# UNITED STATES PATENT AND TRADEMARK OFFICE

APPLICATION NO.	FILING DATE	FIRST NAMED INVENTOR	ATTORNEY DOCKET NO.	CONFIRMATION NO.
10/726,055	12/02/2003	Edward L. Paas	J-3619	2624
28165	7590	04/04/2006	EXAMINER	
S.C. JOHNSON & SON, INC. 1525 HOWE STREET RACINE, WI 53403-2236			REDDING, DAVID A	
			ART UNIT	PAPER NUMBER
			1744

<b>Office Action Summary</b>	<b>Application No.</b> 10/726,055	<b>Applicant(s)</b> PAAS, EDWARD L.	
	<b>Examiner</b> David A. Redding	<b>Art Unit</b> 1744

**FIG. 1****FIG. 2**

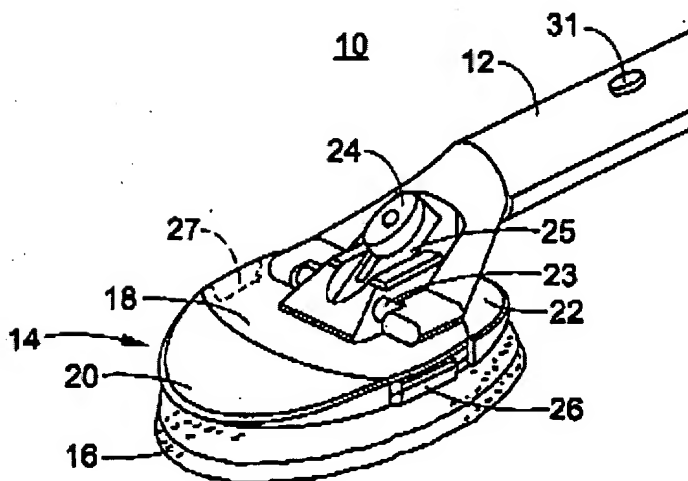
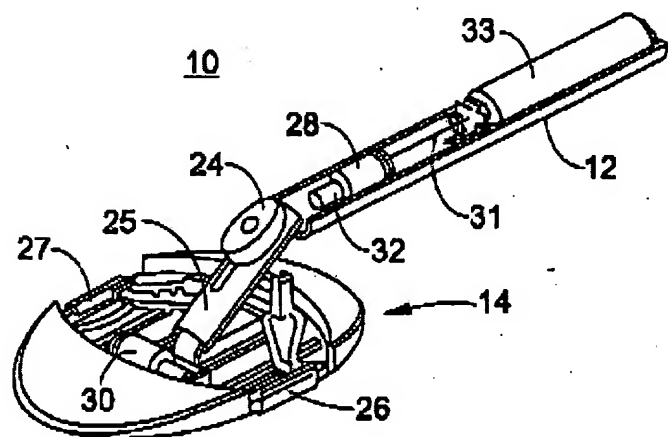
Claims 1-5 are rejected under 35 U.S.C. 102(e) as being anticipated by US 2006/0010625 (Tapper et al.).

The Tapper et al. patent disclose a cleaning system (10) comprising a head including a housing (18), a manually operated handle (12), at least one vibratory unit (30) mounted in the housing (18), and a cleaning pad (16). Although the handle is rigid, plastic is flexible and in the tubular form is considered to inherently oscillate. The vibratory unit (30) includes a rotating shaft having an eccentrically mounted weight (32) which being constructed and positioned as claimed would impart a substantially vertically oriented vibration to the housing (18) as claimed. The device also includes rechargeable batteries and a power switch (31) (paragraph [0042]).

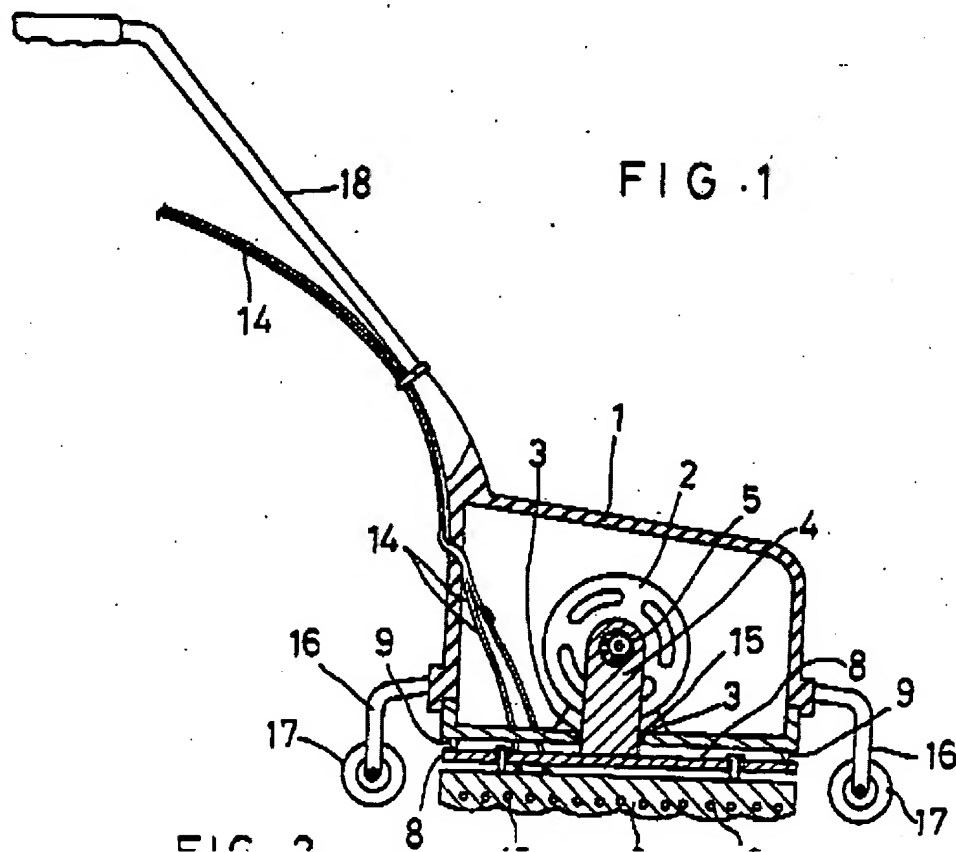
Claims 1-3 and 9 are rejected under 35 U.S.C. 102(b) as being anticipated by USP 5,309,593 (Yonechara).

Figures 1 and 3 illustrate the embodiment which anticipates the claims. The reference discloses a device which comprises a housing (1) having a vibrating plate (8) which can be equipped with a cloth (19) for cleaning a hard surface. The device also includes a handle (18) which would to some degree, inherently oscillate with respect to the housing (1). The housing includes an eccentric weight (2) mounted on a rotating shaft (6) which are connected to an arm (4) connected to the vibrating plate (8). The vibrations are substantially in a vertical direction. The frequency of oscillations are in the range claimed (see col.6, lines 1-5; col.8, lines 5-10).
